UNITED STATES PATENT AND TRADEMARK OFFICE

Office Action Summary	Application No.	Applicant(s)
	10/816,668	SIMOFI-ILYES ET AL.
	Examiner Erik D. Preston	Art Unit 2834

DETAILED ACTION

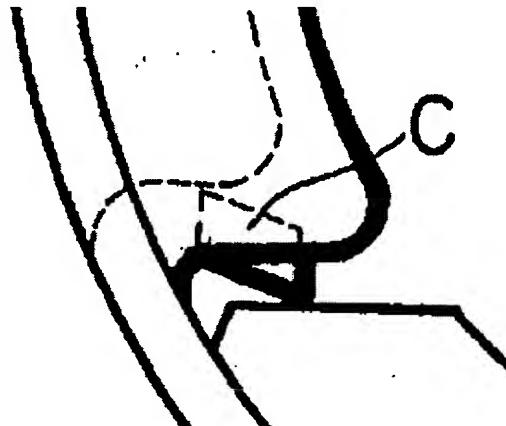
However, Yamaguchi teaches a stator body wherein, in section, the at least one raised portion (Fig. 3, d) is joined directly with a surface defining the recess (Fig. 2, #1a) by a generally S-shaped structure thereby defining an entirely curved and non-planar transition there-between (as seen in Fig. 3, enlarged below). It would have been obvious to one of ordinary skill in the art at the time of the invention to modify the S-shaped structure of McMillen in view of the S-shaped structure as taught by Yamaguchi because it provides a means for holding magnets in a case without requiring any binding agent, springs or screws (Yamaguchi, Abstract).

In response to the applicant's argument that Yamaguchi teaches a planar portion and not an S-shaped transition, it is noted that the S-shaped portion is indicated by the dashed line in figure 3, and not the bold line.
